Scheme Update following Public Consultation

Clonskeagh Road Pedestrian & Cycle Improvements (UCD to Clonskeagh Bridge)

Client: Dún Laoghaire-Rathdown
County Council

Date: Oct 2020

Figure 1: Extract from Google Streetview showing the location of the 'pinch point' and where the right turn onto Beech Hill Road will be removed

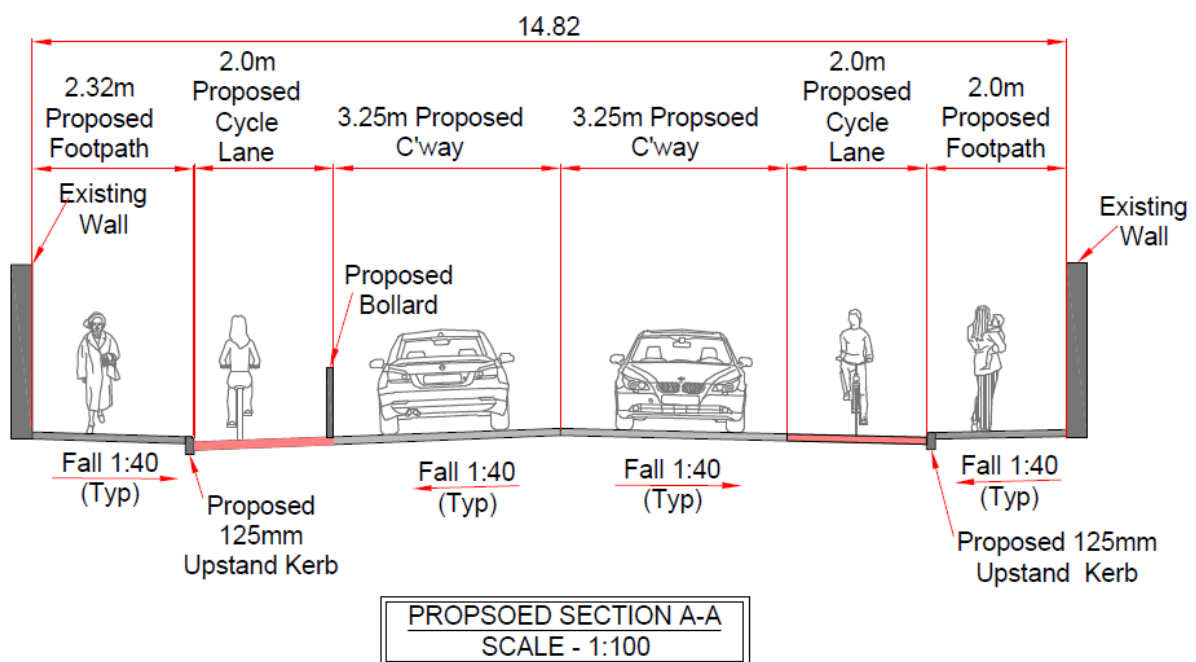
- i. Lack of continuous segregated 2m wide cycle track and footpath throughout the scheme and requested that the route shall be made safer for cyclists and pedestrians with more protection, especially at the 'pinch-point',
- ii. The right turn into Whitebeam Road and/or Whitethorn Road junctions, which are often used by joggers in the morning and evening to access to Milltown/Dundrum and beyond and causes hazards to cyclists and delays to motorists on Clonskeagh Road.

- i. Removal of existing right turn lane approach from Clonskeagh Road northbound to Beech Hill Road (right turning from a straight and right lane will be permitted),
- ii. Removal of access for vehicular traffic into Whitebeam Road from Clonskeagh Road while permitting entry for cyclists, and
- iii. Revised bus stop layouts at 2No. bus stops.

Removal of right turn lane onto Beech Hill Road (Recommended Scheme)	<ul style="list-style-type: none"> Removes <i>pinch-point</i> on cycle-lane and footpath, which allows provision of 2.0m wide cycle lane/track and footpath on both sides of the road. More convenient and safer for cyclists and pedestrians. Cyclists are protected by bollards as an additional safety measure. Potential reduction in traffic volume on Clonskeagh Road as people who used to use this route to get to city centre and beyond may look for alternative routes, adjust their time or travel or change mode. 	<ul style="list-style-type: none"> The junction capacity will be reduced significantly as vehicles turning right and going straight will be sharing the same lane. There will be longer waiting times and longer vehicular queuing lengths at the junction, especially during the morning peak hour (between 8am to 9am). People who used to use this junction to go the city centre and beyond may look for alternative routes, which may increase traffic volumes on other routes.
